**CITY OF AUSTIN – TRAVIS COUNTY – SINGLE SUBDIVISION OFFICE
SUBDIVISION APPLICATION – MASTER COMMENT REPORT**

CASE NUMBER: C8J-2022-0273.1A
UPDATE: U0
CASE MANAGER: Sarah Sumner Phone: 512-854-7687

PROJECT NAME: Lagos Austin-Section 2 Phase 1
LOCATION: 11215 N FM 973 RD

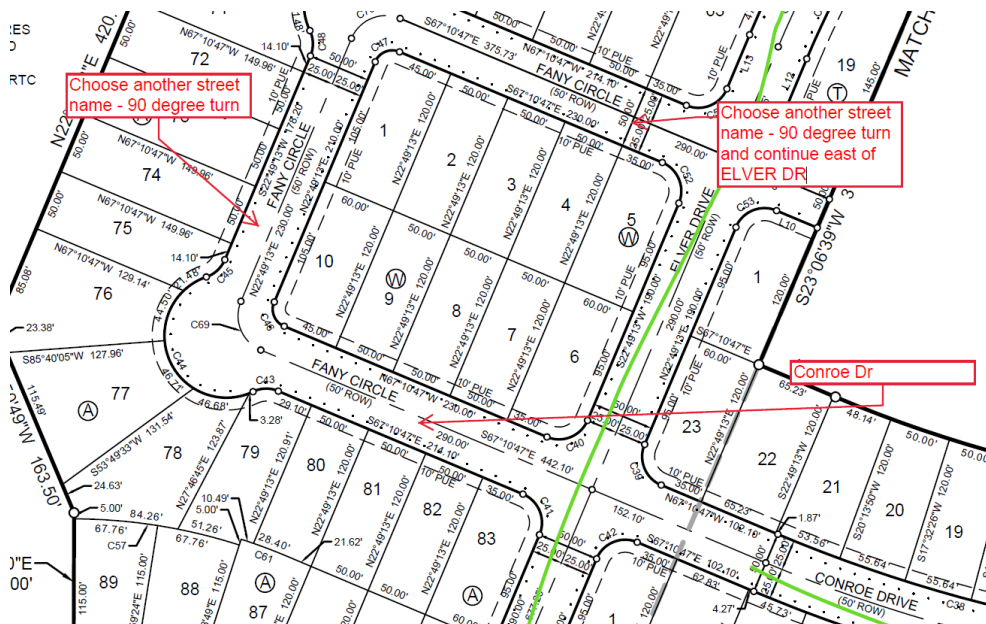
AD3: The segment labeled FANY CIR and Conroe Dr is one continuous street and should only have one street name. Replace FANY CIR with Conroe Dr as it continues to the east.

AD4: Please choose 2 other street names as shown on the image below
